### Coast Guard

[Docket No. USCG–2004–18939]

### Pollution Prevention Equipment

**ACTION:** Interim rule; request for comments.

FIGURE 162.050–17(a)—SEPARATOR TEST RIG

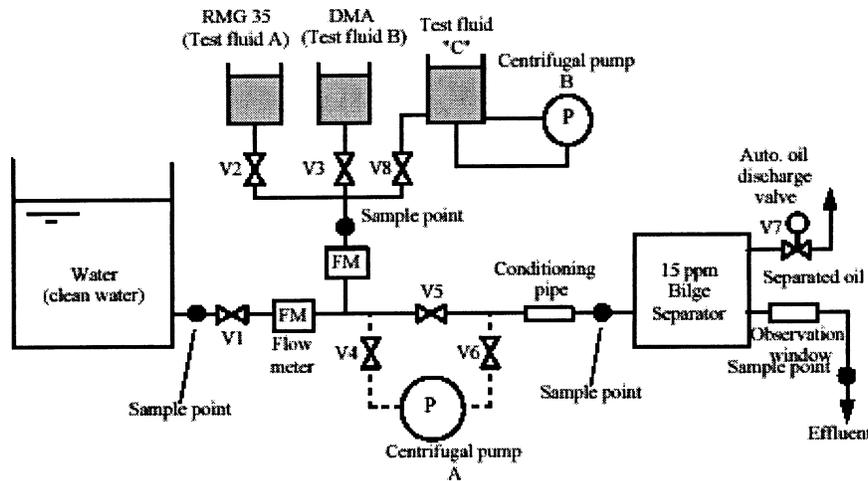
- 26. In § 162.050–17—
- a. Revise Figure 162.050–17(a) to read as set out below;
- b. Revise paragraphs (b)(1), (b)(2), (c)(1), and (c)(3) as set out below;
- c. Remove the reference to “162.050–17(e)” in paragraph (d), and add, in its place, the reference “162.050–17(d)”;
- and
- d. Remove Figure 162.050–17(e) and add, in its place, Figure 162.050–17(d) to read as follows:

- (b) \* \* \*
- (1) Be a centrifugal pump capable of operating at 1,000 revolutions per minute or more;
  - (2) Have a delivery capacity of at least 1.5 times the maximum throughput at

- which the separator being tested is designed to operate;
- \* \* \* \* \*
- (c) \* \* \*
- (1) Influent water flows at a Reynolds Number of at least 10,000;

- (2) \* \* \*
- (3) Its length is at least 20 times its inside diameter.
- (d) \* \* \*

FIGURE 162.050–17(d)—SAMPLE POINT

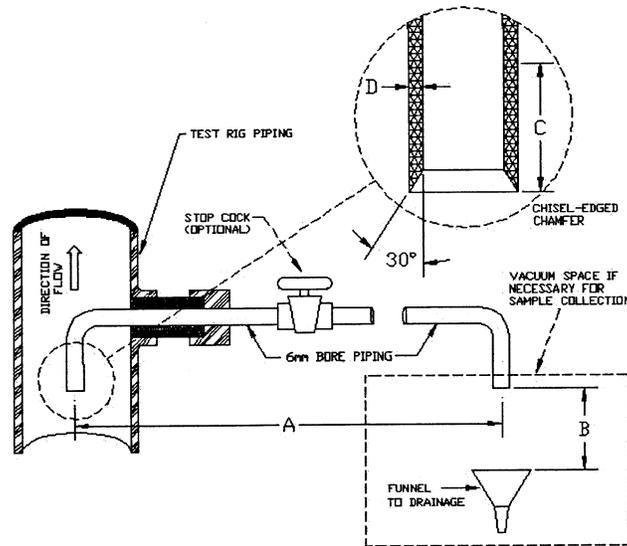
*Issue 57:* One commenter stated that the 30° chisel-edged chamfer in figure 162.050–17(d), Sample Point, should be around the outside perimeter instead of the inside perimeter of the sampler inlet to minimize disturbance of the sampling flow and to be consistent with MEPC.107(49).

*Response:* We agree and have corrected the chamfer illustrated in Figure 162.050–17(d).

FIGURE 162.050-19—MONITOR AND BILGE ALARM TEST RIG

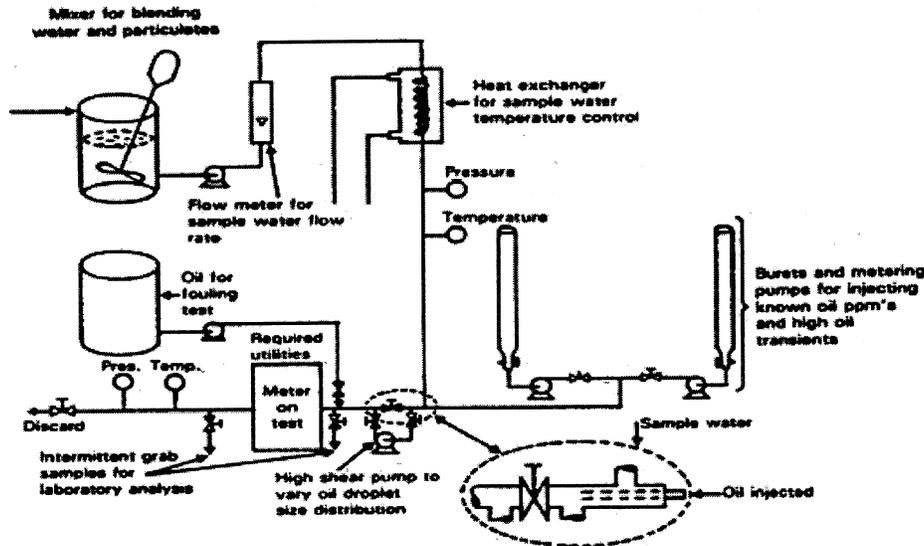
■ d. Revise Figure 162.050-19 to read as follows:

*Response:* The Coast Guard disagrees. Our figure at 46 CFR 162.050–19 and MEPC.107(49) figure 5 stipulate “burets and metering pumps for injecting known oil ppm's and high oil transients,” and thus provide discretion

**Figure 3 - Tank of Test Fluid "C"**

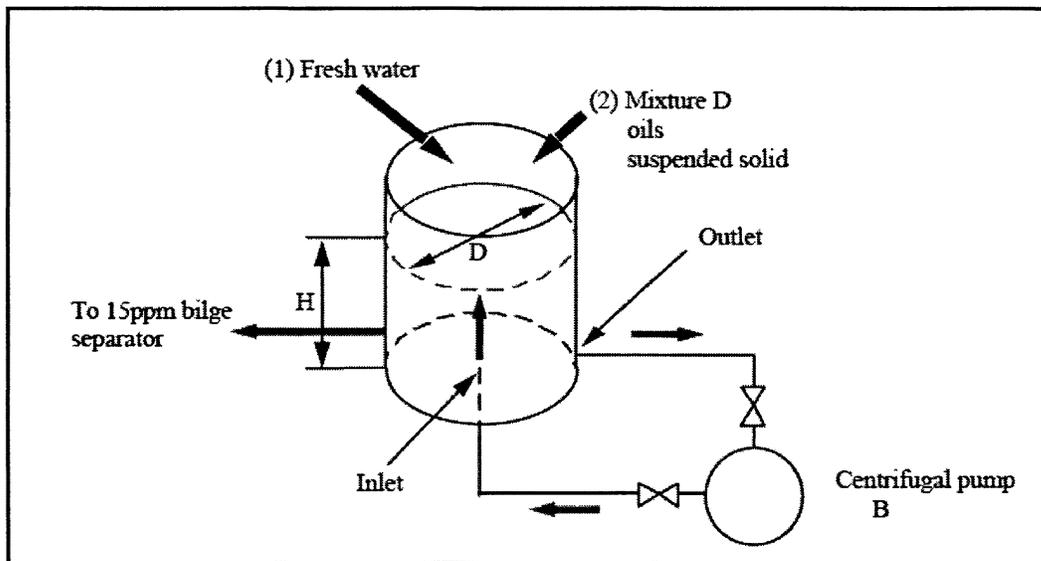
*Issue 60:* One commenter suggested including the specifications of the tank used for Test Fluid C per Figure 3 and notes 1 through 3 of paragraph 1.2.4 of Part I of the Annex to MEPC.107(49) as it would ensure consistent mixing of Test Fluid C by different test facilities.

*Response:* The Coast Guard agrees. Our proposed paragraph (b)(2) of 46 CFR 162.050–20 references a worksheet, figure 162.050–20, for determining Constituents of Test Fluid C. In response to this commenter's suggestion, we are adding MEPC's Figure 3 to that worksheet, and have inserted the notes as text in that worksheet.

(2) Outlet going to centrifugal pump B should be placed at as low a position to the tank as possible.

(3) Inlet to the tank should be fitted at the center of tank bottom so that the mixture flows upward to obtain uniform and stable emulsion.
